Subject: Exchange of propeller switch 25 KB

Concerned: G 103 C TWIN III SL, all S/N's

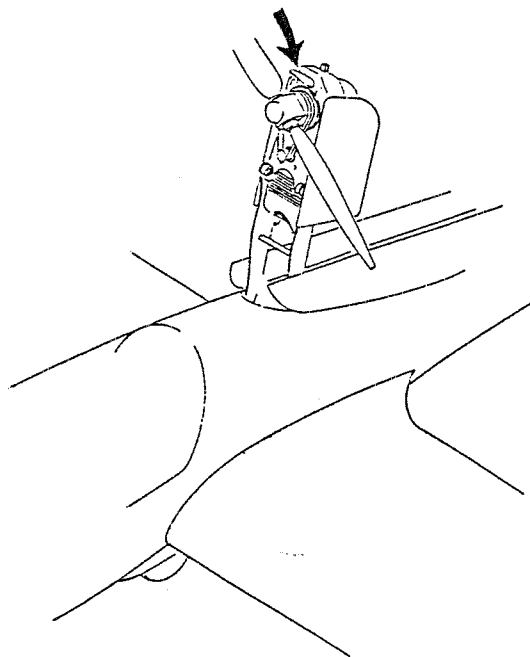
Vorgang: A propeller switch 25 KB, type BALLUFF, is mounted on the engine (see illustration below) which initiates retraction of the engine unit. After approx. 150 engine running hours, chafing through of the insulation of both cables inside this switch, caused by engine vibrations, has been detected. In this condition, the engine retracts immediately, if the ignition is switched to "OFF".

The propeller switch 25 KB must be exchanged as follows:

1. Extend engine until switch 25 KB, mounted on the R/H upper gear support, is accessible. Switch Ignition to "OFF" and "Engine electrics" off.
2. Remove L/H and R/H engine fairings.
3. Remove all cable clamps (1) down to the plug.
4. Disconnect plug.
5. Turn the propeller from the vertical position to release the switch.
6. Undo the 2 switch mounting screws (2) and remove switch.

7. Install modified switch (marked 25-KB-13) using the 2 screws and new lock nuts.
8. Adjust the position of the switch, so that it is actuated by the stop plate (3) with the propeller in the vertical position, tighten mounting screws.
Warning: The stop plate must not have contact with the switch housing to prevent damage to the switch!
9. Check the switch adjustment again, when turning the propeller by hand.
10. Connect plug and fit the cable with new cable clamps.
11. Perform a function test as follows:
 - switch on "Engine electrics"
 - retract the engine electrically and
 - turn the propeller out of the vertical position and check that retraction stops immediately
